033_BUGCR033_Software_Update_VR17.4_VR3.2.docx_or_VR3.2

Bugatti Chiron & Divo

Vehicle Software update to latest homologated specification.

Figure 4 : Gluing procedure

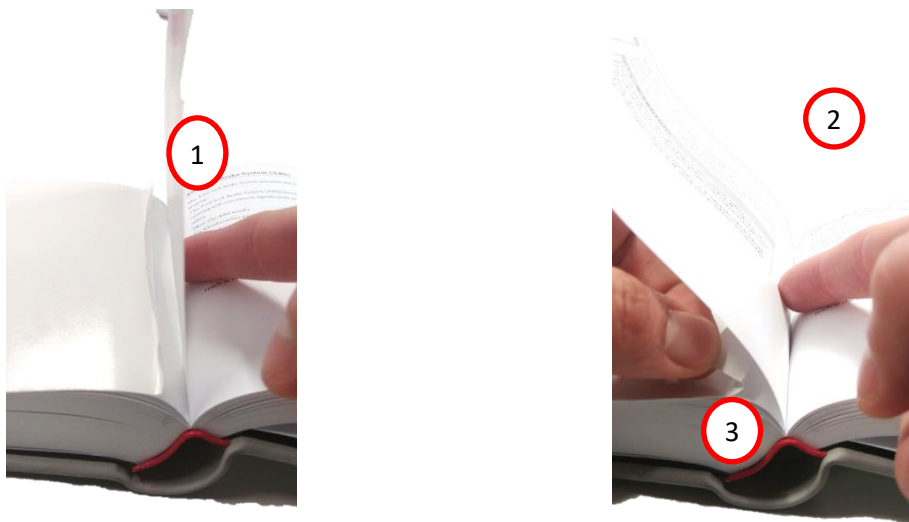
!!! Before sticking the pages, make sure the text is in the good direction !!!
